From: Peter Eakland, Traffic Consultant (TE 1673),

Subject: Recommendations for Revising the Final EIR to Improve Safety for Driveways and Internal Circulation at the Proposed ARCO Gas Station and Convenience Store

Re: Green Valley Convenience Center EIR and Project Approval

Figure 1. Comparison of Final EIR and PBE Recommendations for Driveway Entrance Taper

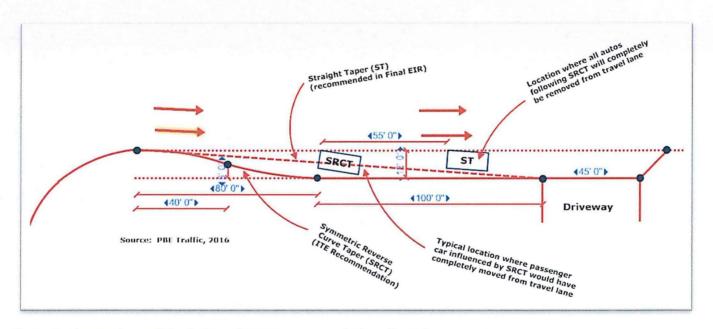
The design that I am proposing closely follows detailed recommendations for the design of combination taper+full lane combinations. My remarks focus on the difference between the design concept contained in the Final EIR, a straight taper, and the concept strongly endorsed in a book of recommended design standards, Transportation and Land Development, 2<sup>nd</sup> ed. (2006), which is a symmetrical reverse curve taper. Figure 1 shows for ease of comparison this design with my recommendation, which is termed a symmetrical reverse curve taper, as described in the Institute of Transportation Engineers book of standard practices. The symmetrical reverse curve taper is 80 ft. long and the remaining 100 ft. is a full lane (including the four-foot bike lane). Both designs have tapers that are 180 ft. in length but are clearly not functionally equivalent for the project, as demonstrated by the following text from the ITE publication.

Statements were made in the Final EIR that the proposed straight taper is functionally equivalent to the "pocket lane" to which it was compared. That "pocket lane", however, did not have a taper long-enough to guide vehicles and cannot be compared to what I have proposed. The symmetrical reverse curve taper can be considered as creating a "pocket" lane providing two useful references for deceleration independent of vehicle type: a taper 80 feet long ending with a full lane 100 ft. long.

Figure 2. Figure 5-27 from ITE Publication Transportation and Land Development, p. 5-58.

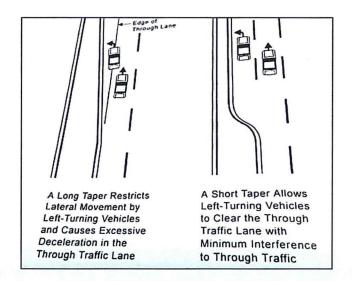
It is recommended that a standard length be adopted in lieu of taper ratios that are a function of design speed. A standard taper length of 100 ft. is suggested for single left-turn and right-turn lanes; 150 ft. is suggested for dual turn lanes. Shorter taper lengths are appropriate in business districts where speeds are 25 mph or less. Where a very short auxiliary lane must be used, the taper should be shorter than the full-width portion.

Figure 4. Location of Recommended Traffic Measures

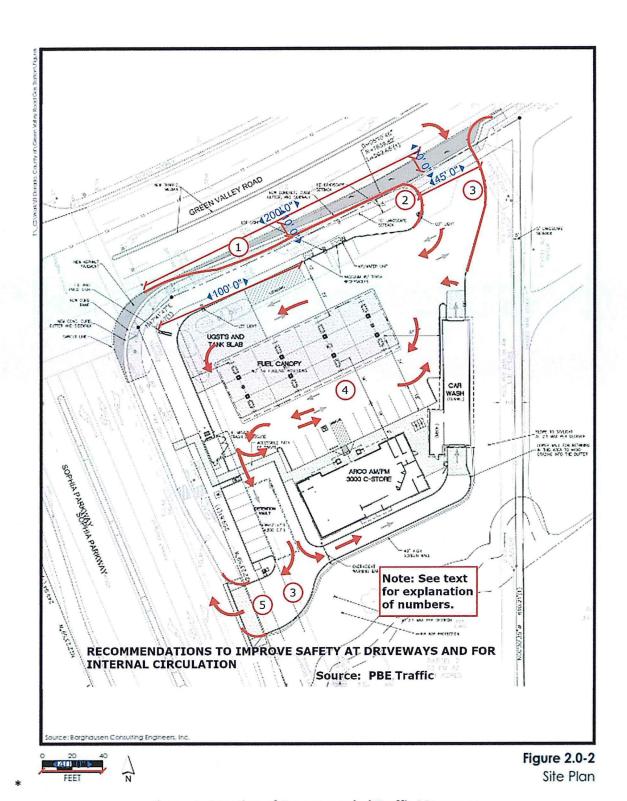
- Green Valley Driveway Safety Improvements. The proposed driveway has a standard driveway connection to the curb but on the west side should have a turning radius of at least 20 ft. to facilitate right turns for entering traffic. Also, no acceleration lane, and a 30 ft. turning radius is recommended where the existing curb meets a tangent line from the driveway. The reasoning that traffic will wait for adequate gaps in traffic before turning right has several problems. Drivers have difficulty in selecting gaps in traffic travelling at 55 mph, especially when a vehicle is towing a boat. The large gap required for a safe movement directly onto a travel lane likely will create queues of several vehicles that could impact internal circulation.

- One-way entrance on Green Valley Road and one-way exit on Sophia Parkway. Creating separate driveways for entering and exiting traffic has several advantages, as follows: Given the addition of Uturns for westbound traffic and Green Valley Parkway and the existing median on Sophia Parkway that extends past the proposed driveway, all vehicles will enter the project site at the Green Valley Road driveway except for northbound Sophia Parkway vehicles. Conversely, all exiting passenger vehicles based on the proposed project almost certainly will utilize the Sophia Parkway driveway except for westbound vehicles. Even these vehicles are likely to select this exit because it offers a safer roadway access and is only a minor detour given the exclusive right-turn lane from the driveway to the intersection. Passenger vehicles desiring to travel southbound on Sophia Parkway can make a U-turn at the intersection, but larger vehicles will be required to make a detour.

Change current northbound turn movement signing on signal mast arm. The current sign is as shown to the right – right turns are not prohibited but on the other hand a U-turn arrow is not included with the caption "U-TURN OK". Although a minor change, it should be included as a mitigation.

Figure 1. Comparison of Final EIR and PBE Recommendations for Driveway Entrance Taper

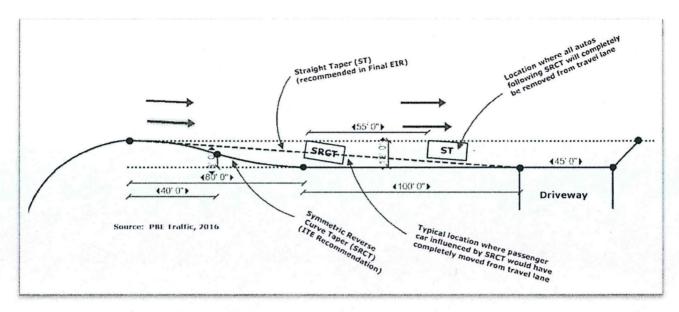
The Final EIR document recommends a straight taper from the access driveway on Green Valley Road offset from the current curb by eight feet, which together with a four-foot bike lane would provide a 12 foot offset from the current outside travel lane. Figure 1 shows for ease of comparison this design with my recommendation, which is termed a symmetrical reverse curve taper, as described in the Institute of Transportation Engineers book of standard practices, <u>Transportation and Land Development</u>, 2<sup>nd</sup> ed. (2006). The symmetrical reverse curve taper is 80 ft. long and the remaining 100 ft. is a full lane (including the four-

foot bike lane). Both designs have tapers that are 180 ft. in length but are not functionally equivalent, as demonstrated by the following text from the ITE publication.

Figure 3. Figure 5-28 from ITE Publication <u>Transportation and Land Development</u>, p. 6-59.

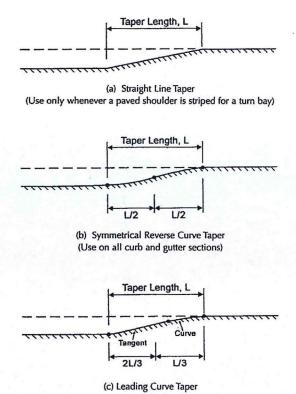
A straight line taper (Figure 5-28a) (Note: provided as Figure 3) is easily constructed and, therefore, commonly is used on highways in undeveloped areas; it is a suitable design where curbs are not present and a paved shoulder is striped for a turn lane. With short tapers, the distinct "corner" at the end and the beginning of the taper creates an abrupt change at the outside edge of the traffic lane, which looks awkward and a vehicle cannot follow. Where curb and gutter is used, tire marks on the curb at the beginning of a straight line taper indicate that this design often results in numerous vehicle impacts. The symmetrical reverse curve design (Figure 5-28b) (Note: provided in Figure 3) provides a smooth transition and is strongly preferred for urban conditions.

Note that in Figure 5-28a the caption reads that for a straight line taper "Use only whenever a paved shoulder is striped for a turn bay." The example provided in the last paragraph in the excerpt is noteworthy that it is virtually the same situation that exists for the proposed project.

Figure 4. Location of Recommended Traffic Measures

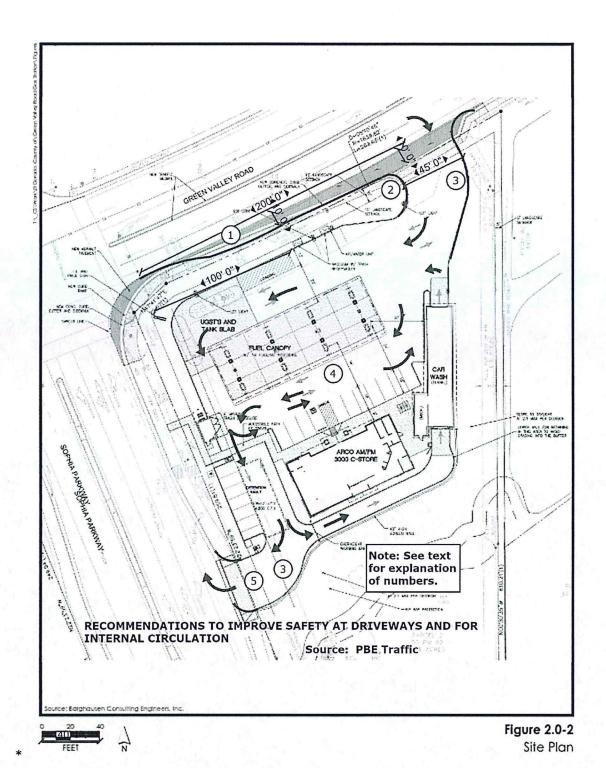
- Green Valley Driveway Safety Improvements. The proposed driveway has a standard driveway connection to the curb but on the west side should have a turning radius of at least 20 ft. to facilitate right turns for entering traffic. Also, no acceleration lane, and a 30 ft. turning radius is recommended where the existing curb meets a tangent line from the driveway. The reasoning that traffic will wait for adequate gaps in traffic before turning right has several problems. Drivers have difficulty in selecting gaps in traffic travelling at 55 mph, especially when a vehicle is towing a boat. The large gap required for a safe movement directly onto a travel lane likely will create queues of several vehicles that could impact internal circulation.

- One-way entrance on Green Valley Road and one-way exit on Sophia Parkway. Creating separate driveways for entering and exiting traffic has several advantages, as follows: Given the addition of Uturns for westbound traffic and Green Valley Parkway and the existing median on Sophia Parkway that extends past the proposed driveway, all vehicles will enter the project site at the Green Valley Road driveway except for northbound Sophia Parkway vehicles. Conversely, all exiting passenger vehicles based on the proposed project almost certainly will utilize the Sophia Parkway driveway except for westbound vehicles. Even these vehicles are likely to select this exit because it offers a safer roadway access and is only a minor detour given the exclusive right-turn lane from the driveway to the intersection. Passenger vehicles desiring to travel southbound on Sophia Parkway can make a U-turn at the intersection, but larger vehicles will be required to make a detour.

Change current northbound turn movement signing on signal mastarm. The current sign is as shown to the right – right turns are not prohibited but on the other hand a U-turn arrow is not included with the caption "U-TURN OK". Although a minor change, it should be included as a mitigation.

Alternative 1 – the pocket lane alternative referenced in the settlement agreement.

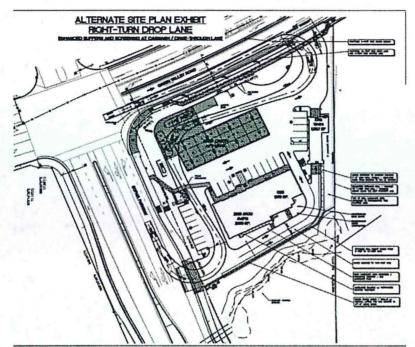
Please analyze traffic impacts including intersection and turning geometrics for autos, autos with boat trailers, gas delivery trucks, and other general merchandise delivery vehicles.

Alternative 2 – illustration of the full deceleration lane alternative referenced in the settlement agreement. Note that it extends from the intersection of Sophia Parkway and Green Valley Road and continues the entire length of the developer's parcel.

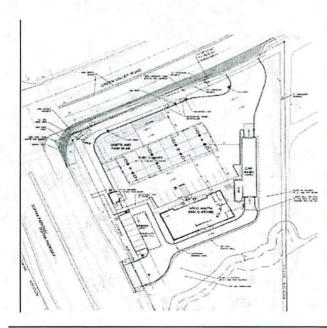
Please provide a detailed analysis regarding costs to move utilities along with analysis of traffic impacts including intersection and turning geometrics for autos, autos with boat trailers, gas delivery trucks, and other general merchandise delivery vehicles.

Figure 1. Comparison of Final EIR and PBE Recommendations for Driveway Entrance Taper

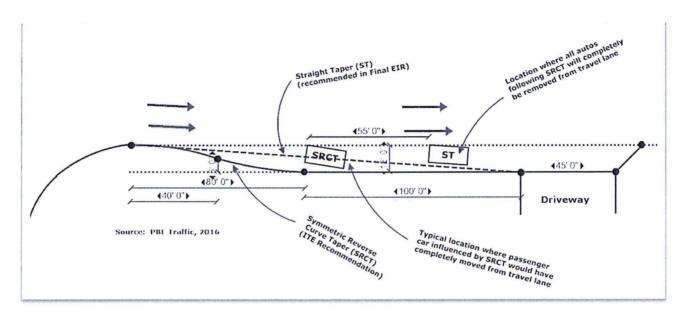
The Final EIR document recommends a straight taper from the access driveway on Green Valley Road offset from the current curb by eight feet, which together with a four-foot bike lane would provide a 12 foot offset from the current outside travel lane. Figure 1 shows for ease of comparison this design with my recommendation, which is termed a symmetrical reverse curve taper, as described in the Institute of Transportation Engineers book of standard practices, <u>Transportation and Land Development</u>, 2<sup>nd</sup> ed. (2006). The symmetrical reverse curve taper is 80 ft. long and the remaining 100 ft. is a full lane (including the four-

Figure 3. Figure 5-28 from ITE Publication Transportation and Land Development, p. 6-59.

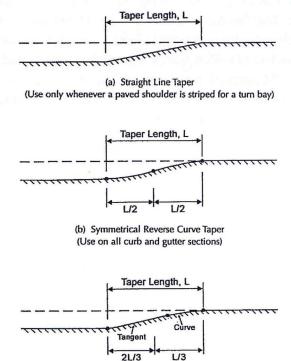
A straight line taper (Figure 5-28a) (Note: provided as Figure 3) is easily constructed and, therefore, commonly is used on highways in undeveloped areas; it is a suitable design where curbs are not present and a paved shoulder is striped for a turn lane. With short tapers, the distinct "corner" at the end and the beginning of the taper creates an abrupt change at the outside edge of the traffic lane, which looks awkward and a vehicle cannot follow. Where curb and gutter is used, tire marks on the curb at the beginning of a straight line taper indicate that this design often results in numerous vehicle impacts. The symmetrical reverse curve design (Figure 5-28b) (Note: provided in Figure 3) provides a smooth transition and is strongly preferred for urban conditions.

Note that in Figure 5-28a the caption reads that for a straight line taper "Use only whenever a paved shoulder is striped for a turn bay." The example provided in the last paragraph in the excerpt is noteworthy that it is virtually the same situation that exists for the proposed project.

Figure 4. Location of Recommended Traffic Measures

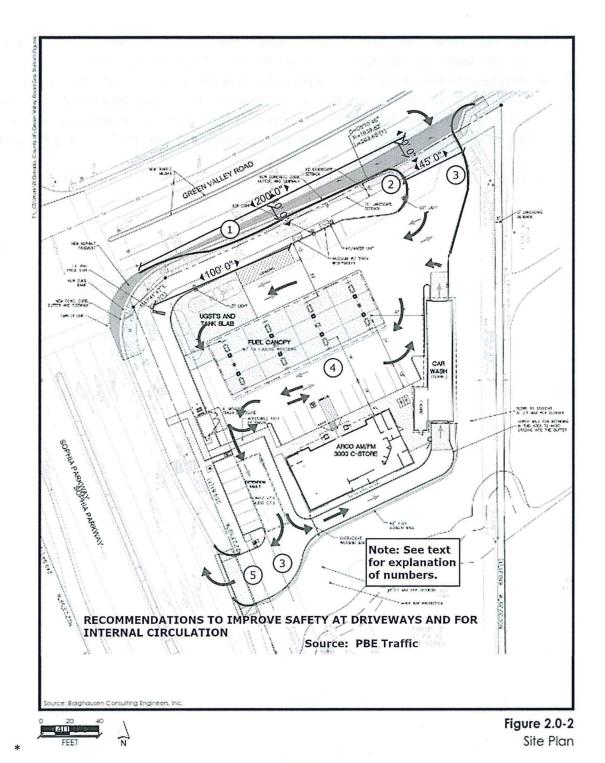
- Green Valley Driveway Safety Improvements. The proposed driveway has a standard driveway connection to the curb but on the west side should have a turning radius of at least 20 ft. to facilitate right turns for entering traffic. Also, no acceleration lane, and a 30 ft. turning radius is recommended where the existing curb meets a tangent line from the driveway. The reasoning that traffic will wait for adequate gaps in traffic before turning right has several problems. Drivers have difficulty in selecting gaps in traffic travelling at 55 mph, especially when a vehicle is towing a boat. The large gap required for a safe movement directly onto a travel lane likely will create queues of several vehicles that could impact internal circulation.

- One-way entrance on Green Valley Road and one-way exit on Sophia Parkway. Creating separate driveways for entering and exiting traffic has several advantages, as follows: Given the addition of Uturns for westbound traffic and Green Valley Parkway and the existing median on Sophia Parkway that extends past the proposed driveway, all vehicles will enter the project site at the Green Valley Road driveway except for northbound Sophia Parkway vehicles. Conversely, all exiting passenger vehicles based on the proposed project almost certainly will utilize the Sophia Parkway driveway except for westbound vehicles. Even these vehicles are likely to select this exit because it offers a safer roadway access and is only a minor detour given the exclusive right-turn lane from the driveway to the intersection. Passenger vehicles desiring to travel southbound on Sophia Parkway can make a U-turn at the intersection, but larger vehicles will be required to make a detour.

Change current northbound turn movement signing on signal mastarm. The current sign is as shown to the right – right turns are not prohibited but on the other hand a U-turn arrow is not included with the caption "U-TURN OK". Although a minor change, it should be included as a mitigation. 8-216-

Alternative 1 – the pocket lane alternative referenced in the settlement agreement.

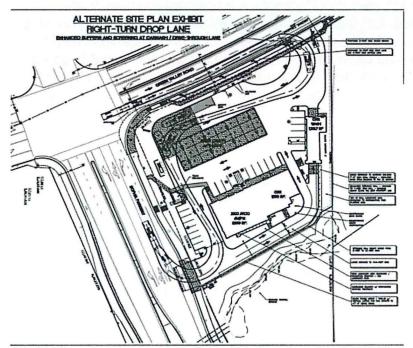
Please analyze traffic impacts including intersection and turning geometrics for autos, autos with boat trailers, gas delivery trucks, and other general merchandise delivery vehicles.

Alternative 2 – illustration of the full deceleration lane alternative referenced in the settlement agreement. Note that it extends from the intersection of Sophia Parkway and Green Valley Road and continues the entire length of the developer's parcel.

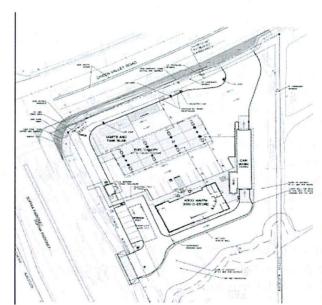
Please provide a detailed analysis regarding costs to move utilities along with analysis of traffic impacts including intersection and turning geometrics for autos, autos with boat trailers, gas delivery trucks, and other general merchandise delivery vehicles.
